Work Order ID 75784

Item Name: Crosstube Turning Detail

DART AEROSPACE LTD		Work Order: 75784
Description: Crosstube Assembly (412 High Aft)		Part Number: D412-664-243
Inspection Dwg: D412-664-243 Rev: E		Page 1 of 1

DRAWING NO. D412-664-243	TITLE CROSSTUBE ASSEMBLY (412 HI AFT)	REV. E	DART AEROSPACE LTD ENGINEERING ORDER		D.E.O. NO. D412-664-243-E-1	SHEET NO. SHEET 1 OF 2	SCALE NTS
DRAWN	CHECKED	MFG. APPR.	APPROVED	DE APPR.			
DATE 11.03.31	DATE 11/03/31	DATE 11.03.31	DATE 11/03/31	DATE 11-03-31

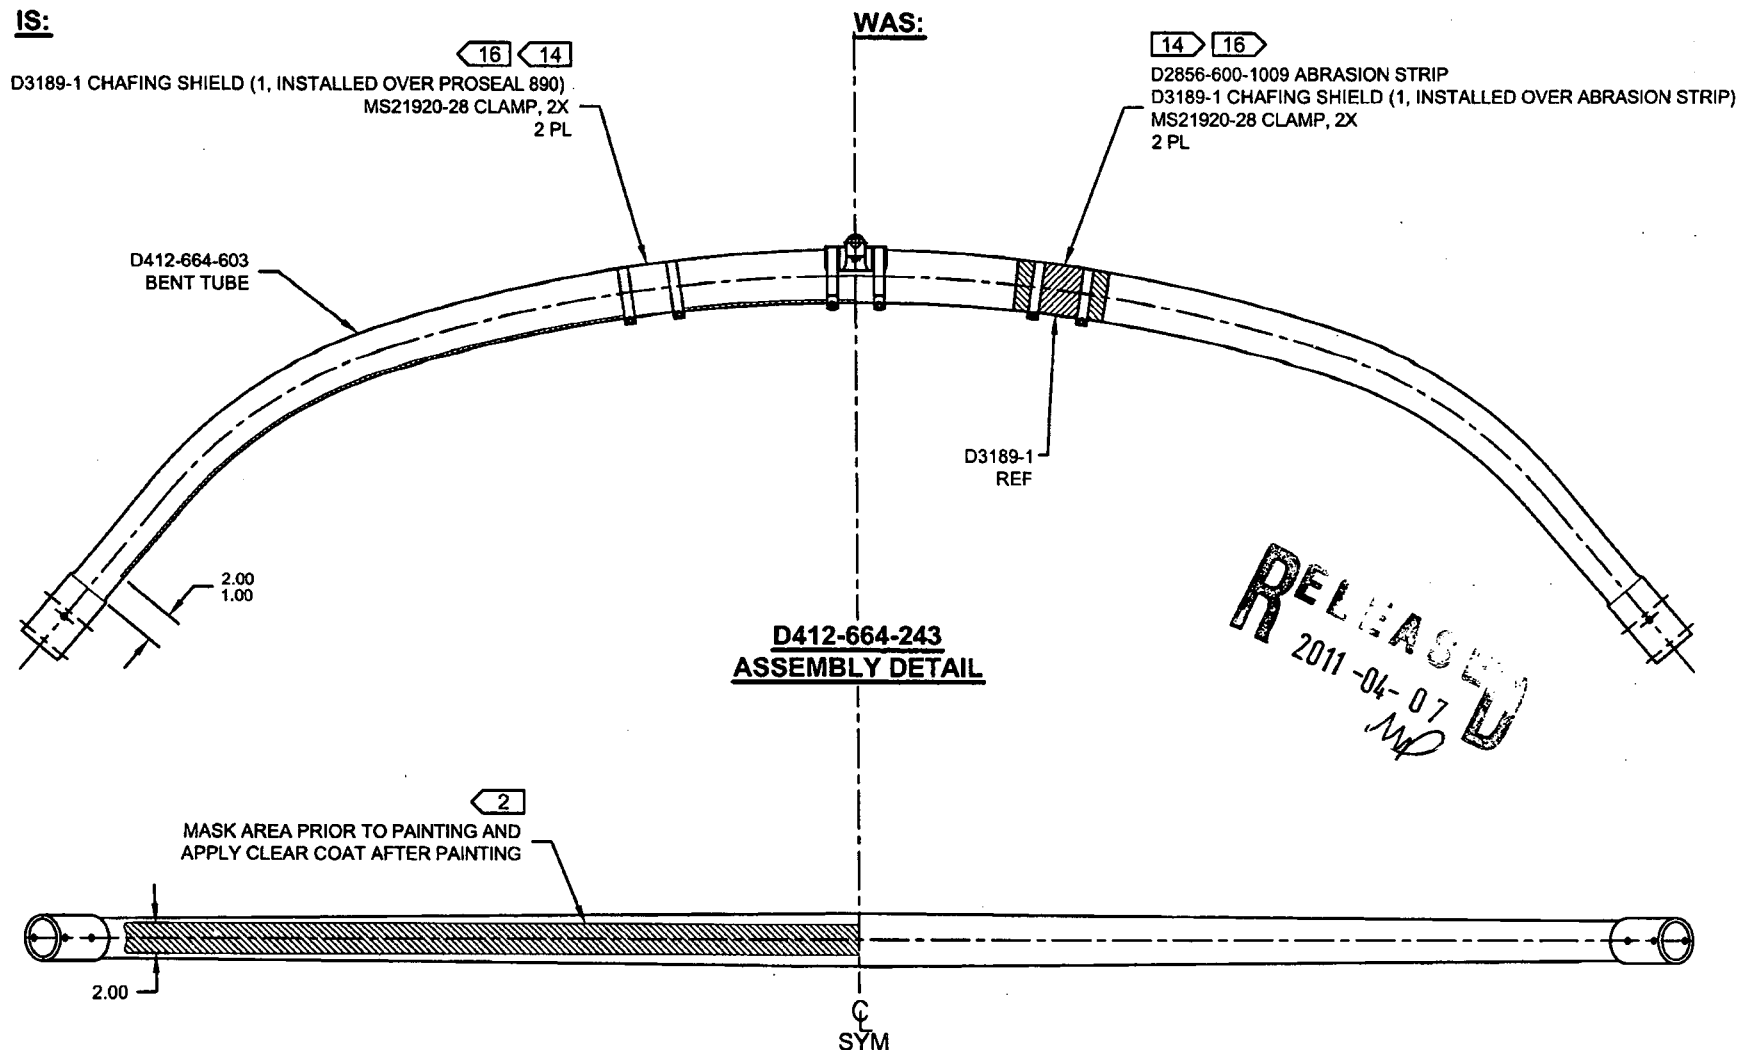
PURPOSE:

REMOVED ABRASION STRIP IN FAVOR OF A THIN LAYER OF PROSEAL 890.

NOTES 2 AND 14, SHEET 1 ARE AMENDED AS FOLLOWS:**IS:**

- 2) FINISH: CHEMICAL CONVERSION COAT PER DART QSI 005 4.1
PRIME INSIDE AND OUTSIDE PER DART QSI 005 4.2
MASK UNDERSIDE OF CROSSTUBE AS SHOWN (HATCHED AREA)
PAINT OUTSIDE PER DART QSI 005 4.2
AFTER PAINTING, APPLY CLEAR COAT ON HATCHED AREA
- 14) APPLY A THIN COAT OF PROSEAL 890 ON INSIDE CONCAVE SURFACE OF D3189-1
CHAFING SHIELD AND LET CURE PER MANUFACTURER'S INSTRUCTIONS. INSTALL
PROSEAL D3189-1 CHAFING SHIELD ONTO CROSSTUBE BY APPLYING A THIN COAT OF
PROSEAL 890 ONTO CROSSTUBE. BE SURE TO ELIMINATE ANY AIR GAPS.

- 2) FINISH: CHEMICAL CONVERSION COAT PER DART QSI 005 4.1
PRIME INSIDE AND OUTSIDE PER DART QSI 005 4.2
PAINT OUTSIDE PER DART QSI 005 4.2
- 14) INSTALL D2856-600-1009 ABRASION STRIPS WITH A 0.13 REF GAP ON BOTTOM SIDE OF
CROSSTUBE PER QSI 035.
